Evaluation Kit for RA4L1 Microcontroller Group  
EK-RA4L1 v1  
Errata

Renesas RA Family  
RA4 Series

**EK-RA4L1 v1**

Figure 1. Debug in Connector

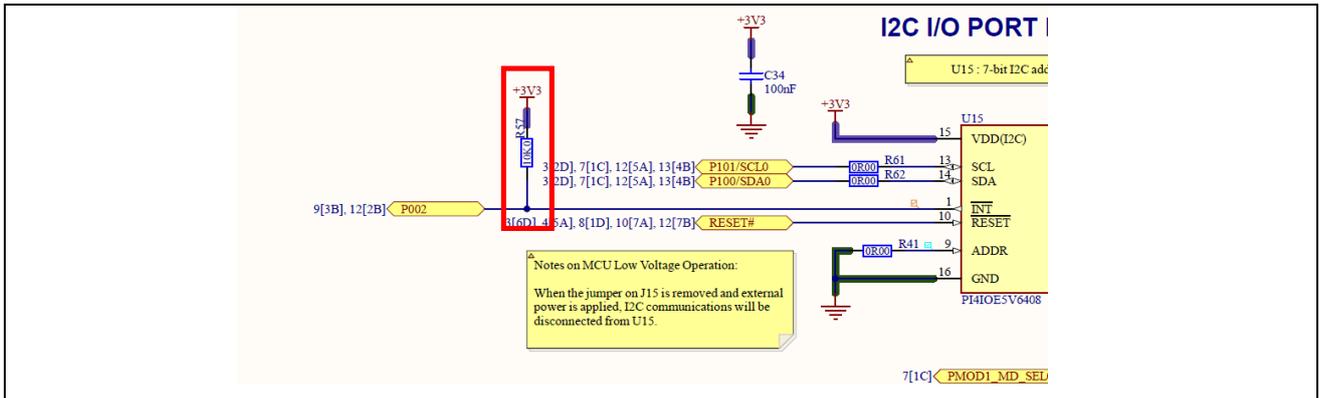
The interrupt pin on the port expander (U15), is pulled up by +3.3V. While in low power mode (MCU Voltage < +3.3V), current will flow towards the interrupt pin.

Please remove R57 before running the EK-RA4L1 in low power mode.
